Subject: AP1000 Response to Request for Additional Information (SRP 6)

Response to Request for Additional Information on SRP Section 6

AP1000 TECHNICAL REPORT REVIEW

View of PXS Room Potential Break Elevations

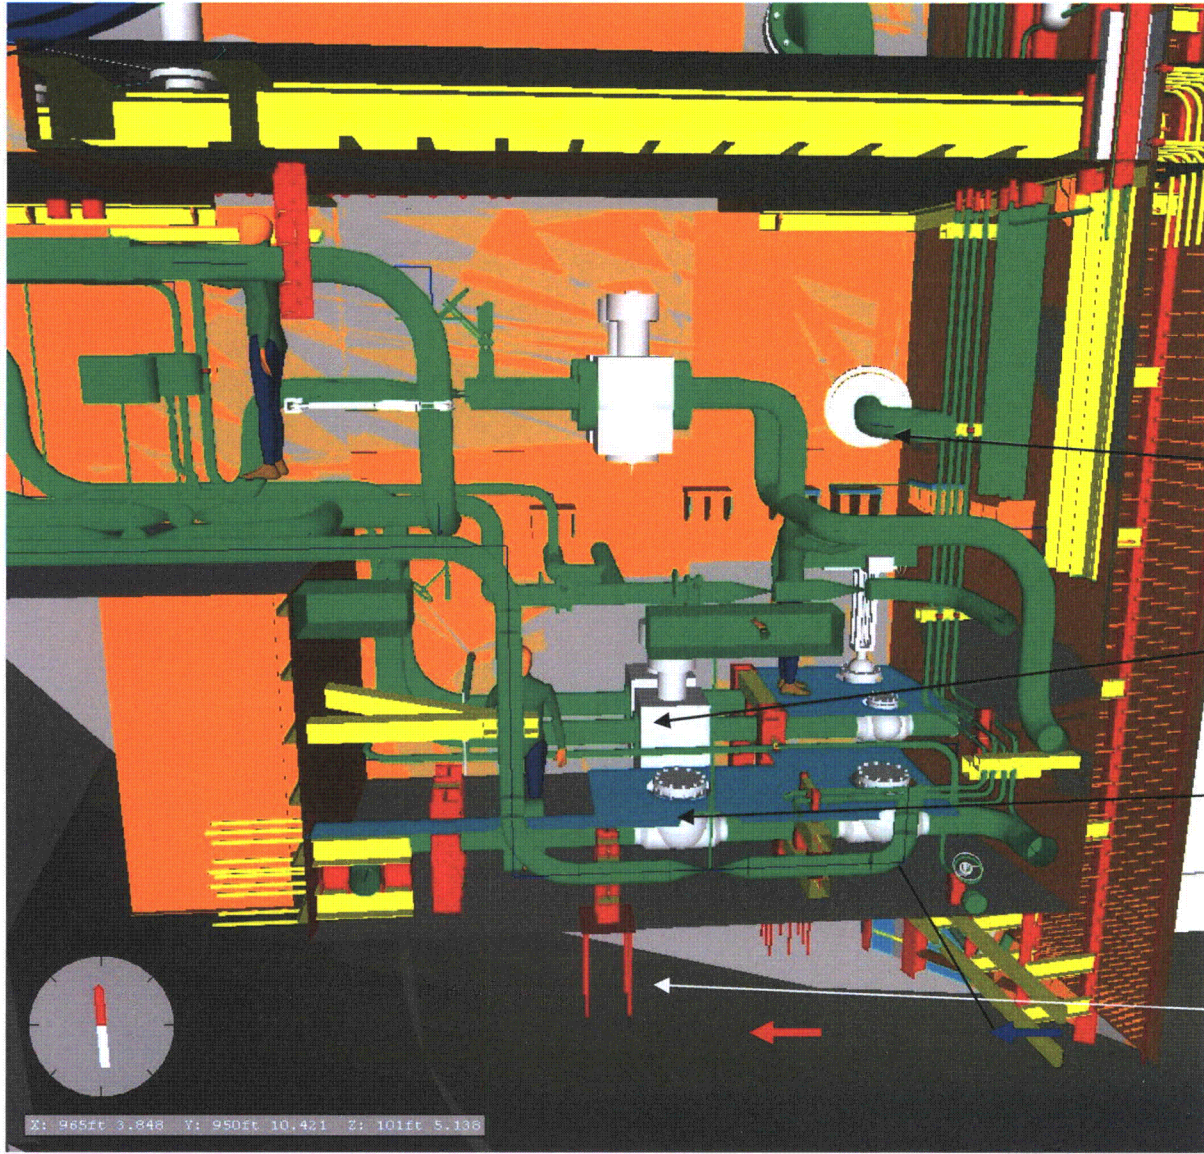
- b. The RAI response states that the thermal hydraulic conditions associated with a postulated break for the AP1000 are the same as those for current operating PWRs. However, the break conditions for AP1000 may be significantly different especially for a DVI break. What is the velocity of the break when water is flowing into the reactor vessel through the break? Will this be larger than .2 ft/sec, which is the velocity that Westinghouse referred to from NUREG/CR-6808?

The figure on the following page provides potential break location elevations in comparison with the room floor elevation. Please note that the lowest of these elevations, designated as the accumulator check valve will not exhibit the flow back into the RCS through the break because the IRWST flow will be either spilling or entering the RCS through this line. This can be seen in the Passive Core Cooling sketch provided.

The associated velocities on the floor can be calculated using the break elevation with a flow area associated with a hemisphere and the maximum core flowrate (60% through the break and 40% through the intact line). Response to RAI-SRP6.2.2-SRSB-10, Revision 1 provides the justification for the flow split through the break DVI line and the intact DVI line.

Figure 1: Containment ID Trends

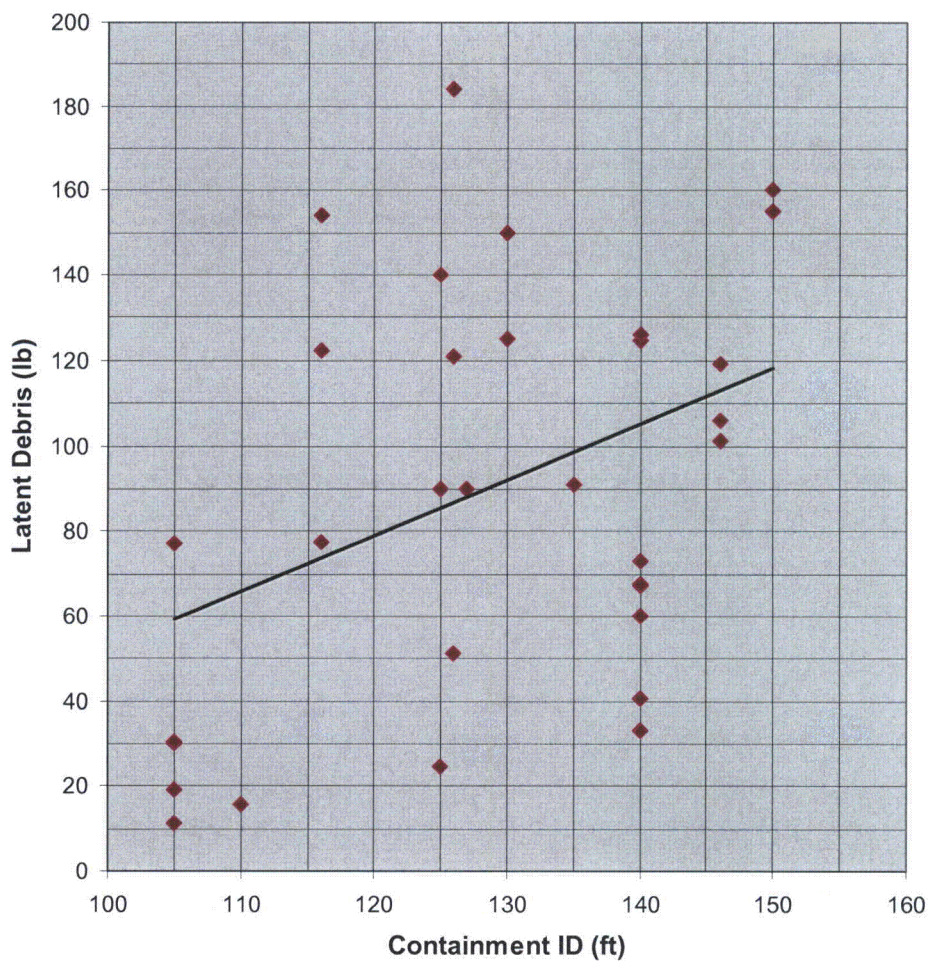
Additional Question:

The data provided in NUREG/CR-6877, 'Characterization and Head-Loss Testing of Latent Debris from Pressurized-Water-Reactor Containment Buildings', supports the position that the amount of latent fiber that is found in operating plants that have performed latent debris walkdowns is small, as opposed to the generic 15% provided in the SER on NEI 04-07. Both NUREG/CR-6877, and the data in the Generic Letter 2004-02, 'Supplemental Responses and Close-Out', support the fact that the mass of latent debris calculated for the AP1000 (APP-PXS-M3C-053, Revision 0) is in line with debris masses found and reported in operating plants.

Using the data in NUREG/CR-6877 and the Generic Letter 2004-02 'Supplemental Responses and Close-Out' responses, it is proposed that the AP1000 will assume 150 pounds of resident debris of which six pounds are fiber which has the potential to transport to the screens. This resident debris mix is supported by both the plant responses in the Generic Letter 2004-02 'Supplemental Responses and Close-Out' (resident debris mass) and NUREG/CR-6877 (fiber content).

Figure 1: Intact Loop DVI Recirculation Flow

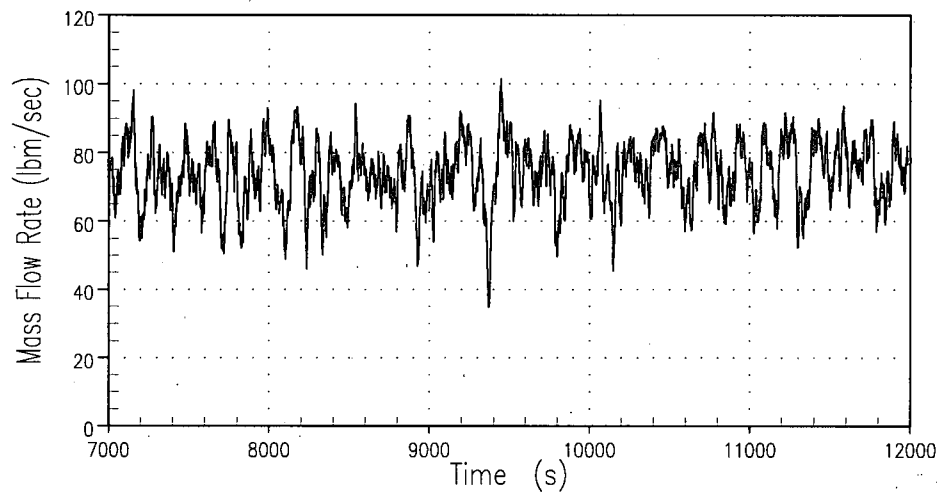
In its review of part a. to the response to RAI-SRP-6.2.2-SRSB-10, the staff asked Westinghouse to identify if the 60% bypass flow assumption was based on low water level in the containment, which would limit the recirculation flow, or was based on a high water level, which could drive a bigger percentage of unfiltered debris through the DVI break location? On review of the calculation APP-PXS-M3C-049 Rev. 0, the staff found that the 60% number was based on integrated flow through the break divided by the total integrated flow into the core region, but time periods during the transient changes this percentage significantly. Describe the variations you expect in this percentage split with respect to time. Also, using the flow percentage splits between the break and the recirculation screens is not an adequate representation of the debris split because sump recirculation screens are protected from debris by barriers such as the large protective shelves above the screens. On the other hand, there are no protective barriers for the break location and it is completely open to all suspended debris in the containment sump area. Clarify how this bias accounted for in the calculation?

The figures on the following pages show the calculation of the flow ratio calculated through the break. Figure 1 provides the intact DVI line flows following recirculation. Figure 2 provides the flow into the reactor vessel from the break location. Figure 3 provides the instantaneous flow ratio in the core from the break location to the total core flow (flow through break to the reactor vessel / total flow to reactor vessel) following recirculation. At all times after recirculation the instantaneous flow through the break ratio is less that 60% of the total core flow.

Figure RAI-SRP 6.2.2-SRSB-11c-1: DCD Chapter 15.6.5.4C Analysis Integrated Core Boiloff Rate, IRWST Injection Phase

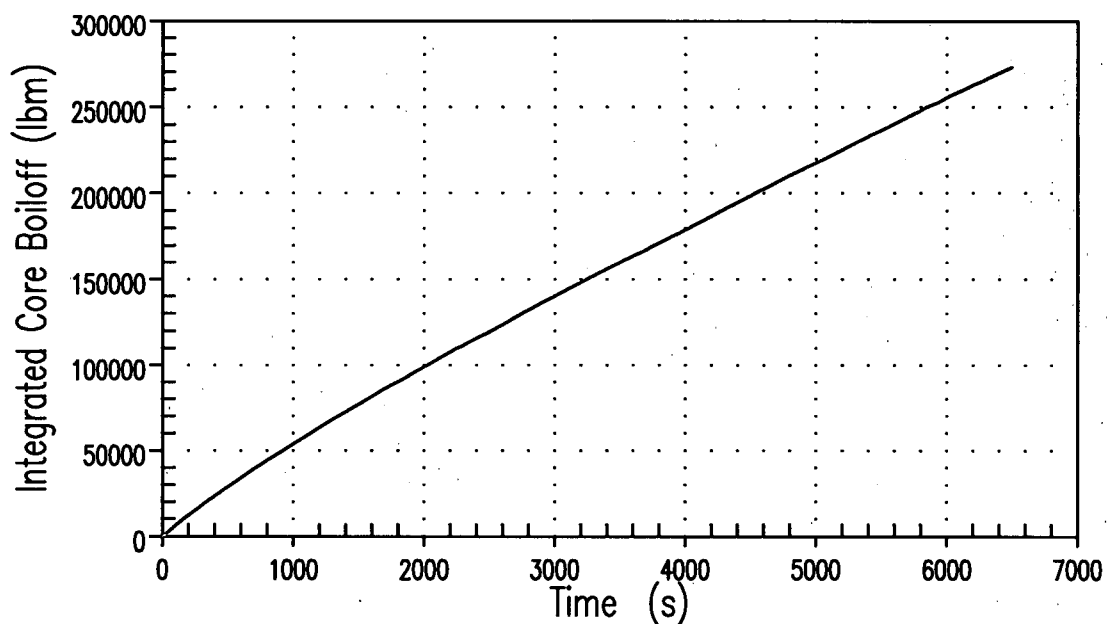
- c. Provide plots of the integrated core boiloff rate and integrated core inlet flow rate for each of the cases analyzed, including the two sensitivity cases.

Each containment recirculation phase case is a window mode computation that begins at 6500 seconds WCOBRA/TRAC problem time and ultimately reflects the quasi-steady-state containment floodup level. The core inlet flow rate integrals show less liquid enters the core in Sensitivity Case 1 than in the DCD analysis, and that less liquid enters the core in Sensitivity Case 2 (the higher resistance sensitivity case) than Sensitivity Case 1. Thus, lower core inlet flow results from the reduced DVI flow rates that are predicted for containment recirculation as a consequence of the postulated sump screen blockages.

Figure RAI-SRP 6.2.2-SRSB-11c-2: DCD Chapter 15.6.5.4C Analysis Integrated Core Inlet Mass Flow Rate, IRWST Injection Phase

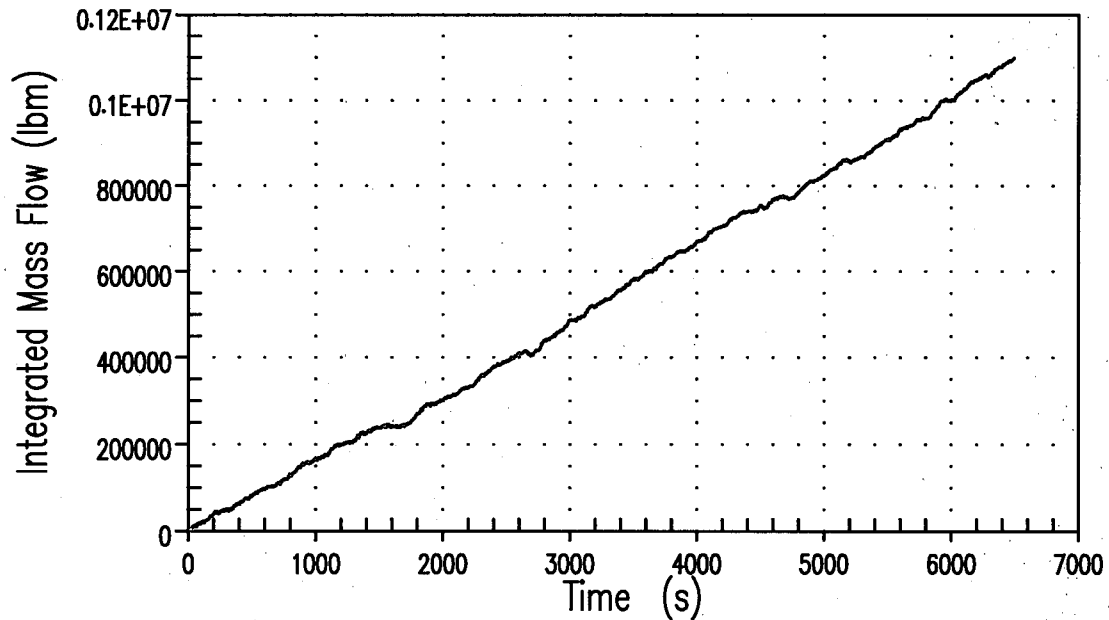
- a. The RAI requested the debris and chemical loading for water bypassing the sump screen and Westinghouse's response refers to TR 26, Revision 3, Table 5 for the latent debris. Table 5 does not provide the answer for a.
- b. When does the reverse flow into the DVI break line occur? What is the time dependent water level in the containment? How is % bypass factor determined from these flows? What is the % bypass during the transient, not the average integrated bypass, but the time dependent % bypass.
- c. Why are the integrated core boiloff for the sensitivity cases (Figures RAI-SRP 6.2.2 – SRSC-11c-5 and -7) lower than that of the DCD base case (Figure RAI-SRP 6.2.2 – SRSC-11c-2) having the same decay heat?
